SERVICE CAMPAIGN BULLETIN

Reference: ITB10-034a COPYRIGHT© NISSAN NORTH AMERICA, INC.

VOLUNTARY SERVICE CAMPAIGN 2003 – 2004 G35 SEDAN AND COUPE SEAT MOUNTED SIDE AIR BAG HARNESS CONNECTOR

This bulletin has been amended. Changes were made on pages 3 and 4, and the Parts and Claims Information were updated. Please discard previous versions of this bulletin.

Figure 1a

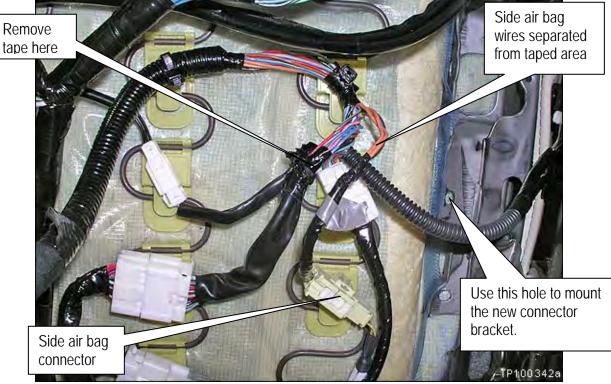
- Some 2003 G35 Sedans have a manual front passenger seat that is not included in this campaign.
- Make sure to perform this procedure on the driver seat and the front passenger <u>power</u> seat.
- Figures 1a through 10a are used for both the driver seat and the front passenger <u>power</u> seat.
- 1. Look under the seat and locate the harness and connectors shown in Figure 1a.
- 2. Remove tape from the area shown in Figure 1a, just enough to separate the Side Air Bag (SAB) wires.

Figure 2a

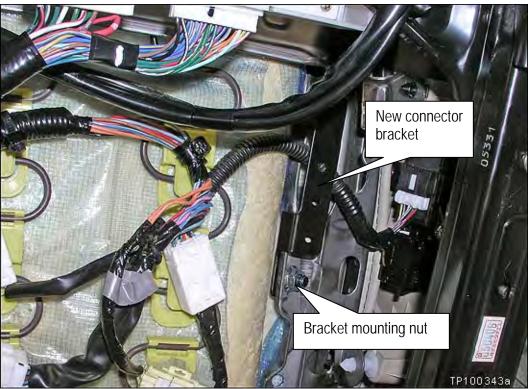
3. Install the new connector bracket as shown in Figure 2a and torque the nut:

17.6 – 26.5 N•m (1.8 – 2.7 kg-m, **13 – 20 ft-lb**)

Figure 6a

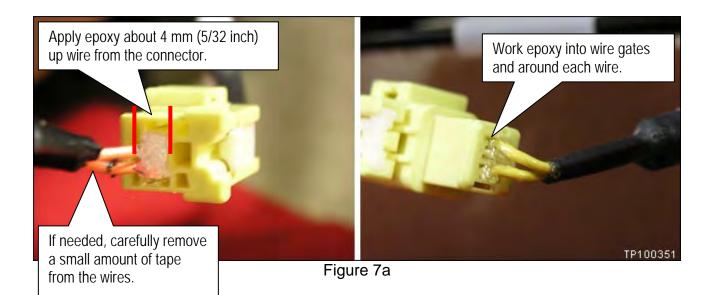
- 8. Place covers on the floor and seat to protect against epoxy spills.
- 9. Apply the epoxy to the back side (wire gates) of the SAB connector (see Figure 7a).
 - Apply epoxy to all 4 wire gates.
 - Work epoxy into the wire gates and around each wire.
 - Apply epoxy about 4 mm (5/32 inch) up the wire from the connector.

Figure 9a

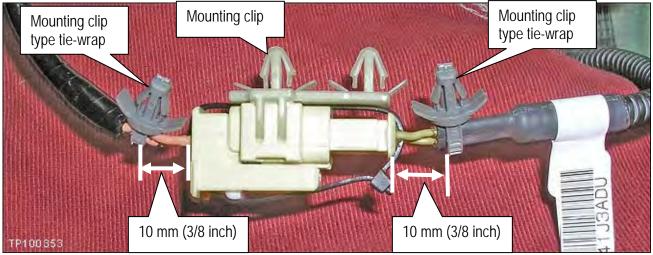
- 11. Reinstall the connector mounting clip (see Figure 9a).
- 12. Install 2 "mounting clip type" tie-wraps as shown in Figure 9a.

Figure 1b

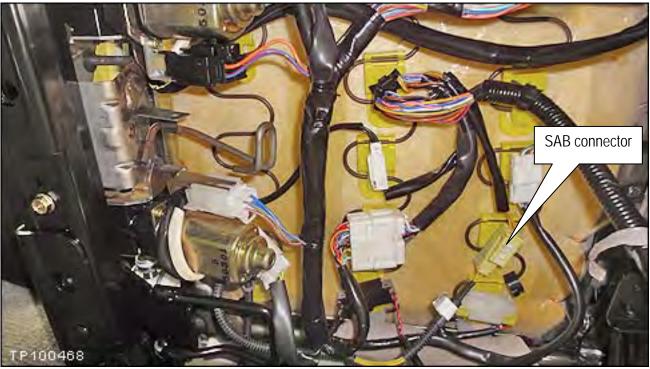
- 1. Look under the seat and locate the Side Air Bag (SAB) connector shown in Figure 1b.
- 2. Snap loose the SAB connector with clip from its mounting position.

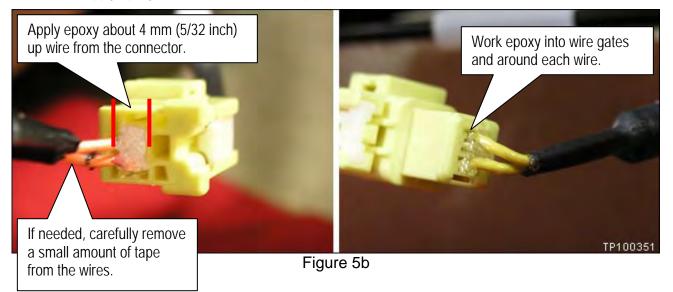
- 6. Place covers on the floor and seat to protect against epoxy spills.
- 7. Apply the epoxy to the back side (wire gates) of the side air bag harness connector (see Figure 5b).
 - Apply epoxy to all 4 wire gates.
 - Work epoxy into the wire gates and around each wire.
 - Apply epoxy about 4 mm (5/32 inch) up the wire from the connector.

Figure 7b

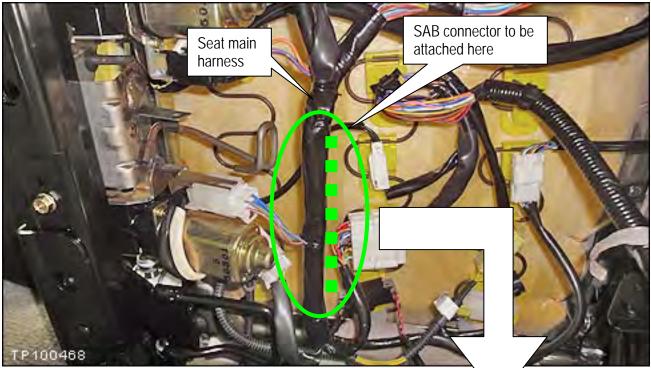
- 9. Attach the SAB connector to the seat main harness as follows:
 - a. First, use tie-wraps to secure the SAB connector to the main harness (see Figures 7b, 8b and 9b).

Figure 9b

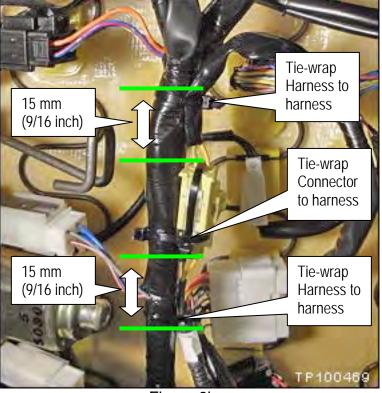
- Make sure the connector is secured to the side of the harness as shown in Figure 8b.
- One tie-wrap (P/N 24216-S5800) harness to connector - as shown in Figure 9b.
- Two tie-wraps (P/N 24216-S5800)
 harness to harness 15 mm (9/16 inch) from the connector as shown in Figure 9b.

Figure 10b

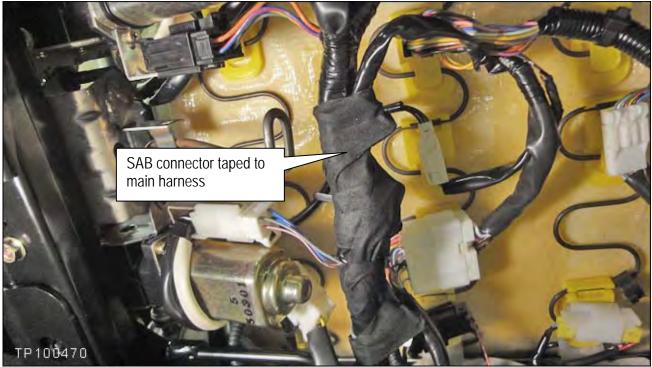
b. Completely tape the SAB connector to the main harness as shown in Figure 10b.

IMPORTANT: Use <u>ONLY</u> specified tape (P/N 24828 – AM00A).

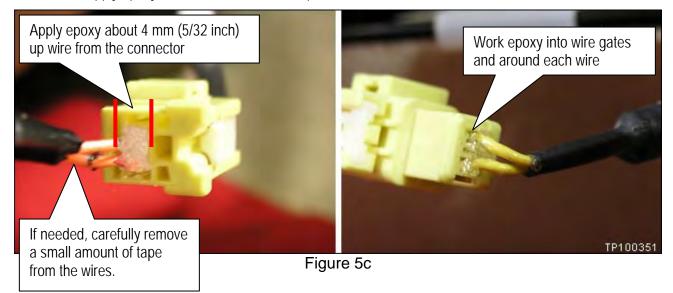
- 6. Place covers on the floor and seat to protect against epoxy spills.
- 7. Apply the epoxy to the back side (wire gates) of the SAB harness connector (see Figure 5c).
 - Apply epoxy to all 4 wire gates.
 - Work epoxy into the wire gates and around each wire.
 - Apply epoxy about 4 mm (5/32 inch) up the wire from the connector.

Figure 8c

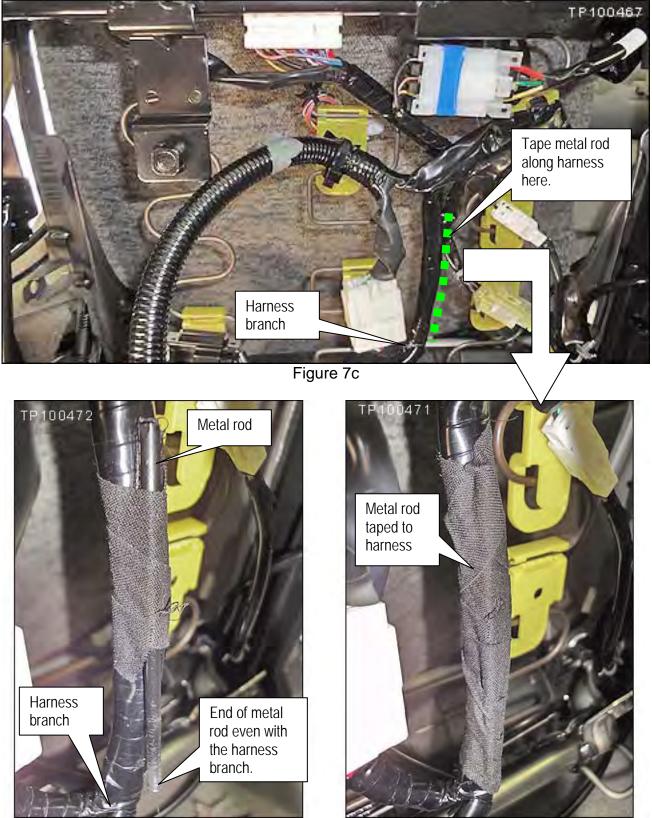
Tape the metal rod (P/N 87607 – CF90A) to the seat harness as shown in Figures 7c and 8c.
 IMPORTANT: Use <u>ONLY</u> specified tape (P/N 24828 – AM00A).

Figure 11c

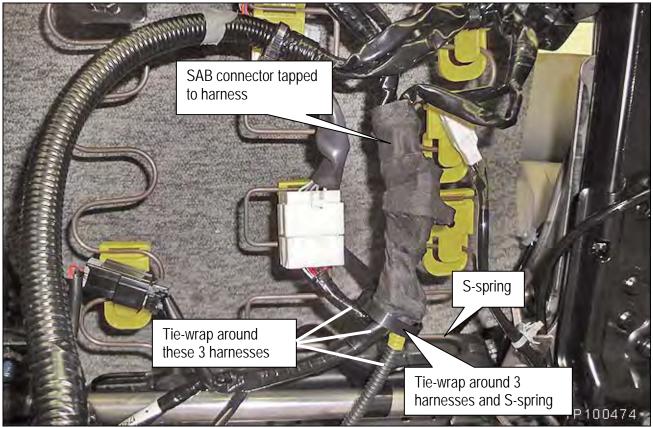
- Completely tape the SAB connector to the seat harness as shown in Figure 11c.
 IMPORTANT: Use <u>ONLY</u> specified tape (P/N 24828 AM00A).
- 12. Attach tie-wrap (P/N 24216 S5800) around harnesses and S-spring as shown in Figure 11c.
 - Cut excess tie-wrap flush so there are no sharp edges.
